TECHNICAL BULLETIN

Front Brake Rattle – Disc Shield – Install New Retaining Screws

70-25

MODEL Sedan Range 1994 - 95 MY
VIN 674930 - 756474

ILLUSTRATION 1

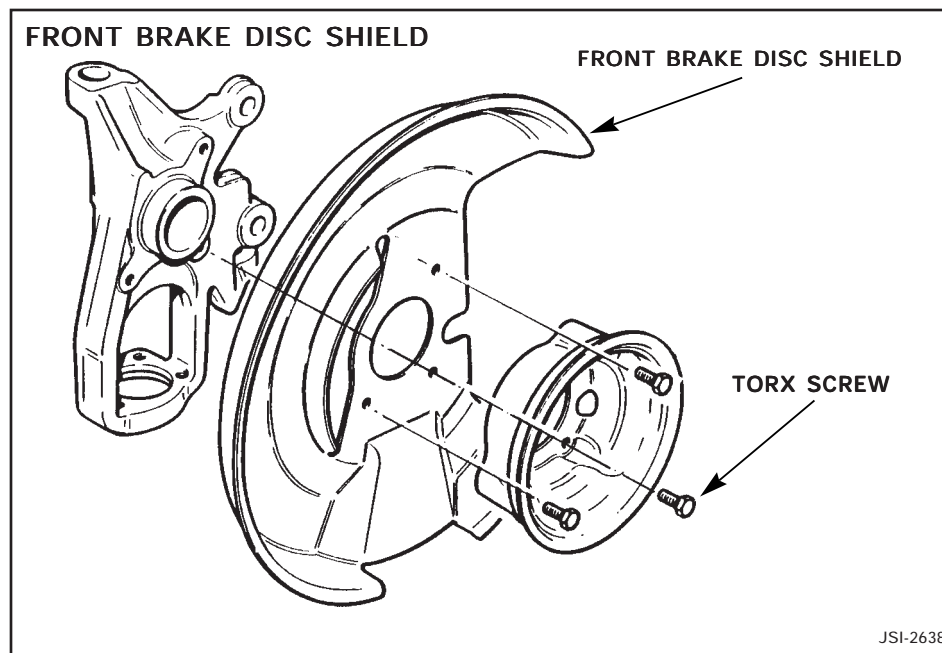
The noise is caused by loosening of the Torx screws that secure the brake disc shield and the water shield to the stub axle, allowing the shields to vibrate.

In case of a customer complaint remove the hub assembly as described in Section 70.10.18 of the XJ6 - XJ12 Saloon Range Service Manual. Remove and discard the old screws. Install the new screws listed in the Parts Information and torque to 7.4 - 8.8 lb. ft. (10 -12 Nm.)

NOTE: When the hub is removed, the seal must be replaced with a new one using Special Tool JD 179. The seal face that contacts the hub must be coated with a special lubricant (Shell Retinex LC). Thoroughly clean all traces of the previous lubricant from the hub.
